International Trading Services Ltd. (10409)

ACCORD
on Fire and Building Safety in Bangladesh

Identified Priority 1 Concerns

Table (a). Allowable Bearing Capacity For Shallow Foundation

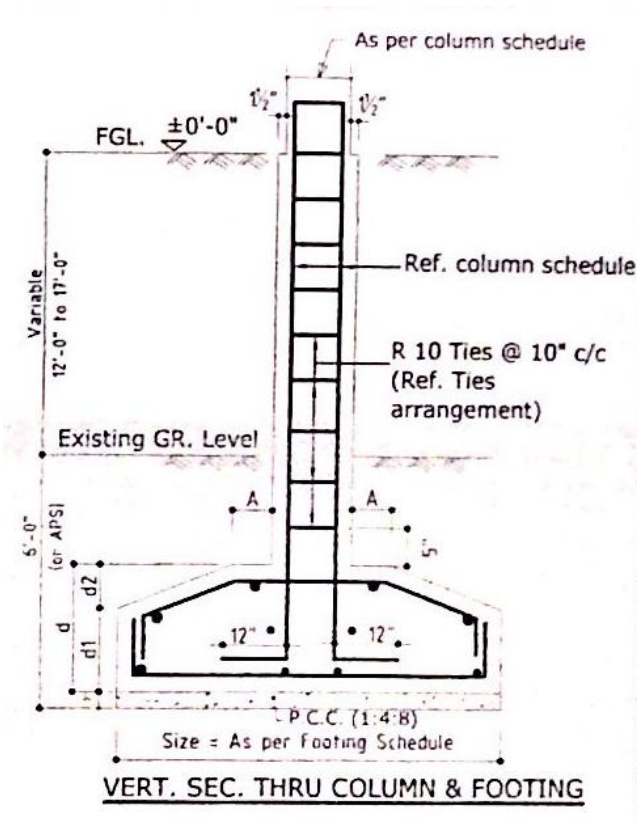
Based upon the provided soils reports, spread footing size is inadequate to properly distribute footing loads to the native clay soil

Low Soil Bearing Capacity

- A Detailed Engineering Assessment to be carried out upon the 6-storey and 11-storey looking into, in particular the building foundations and the Geotechnical findings.
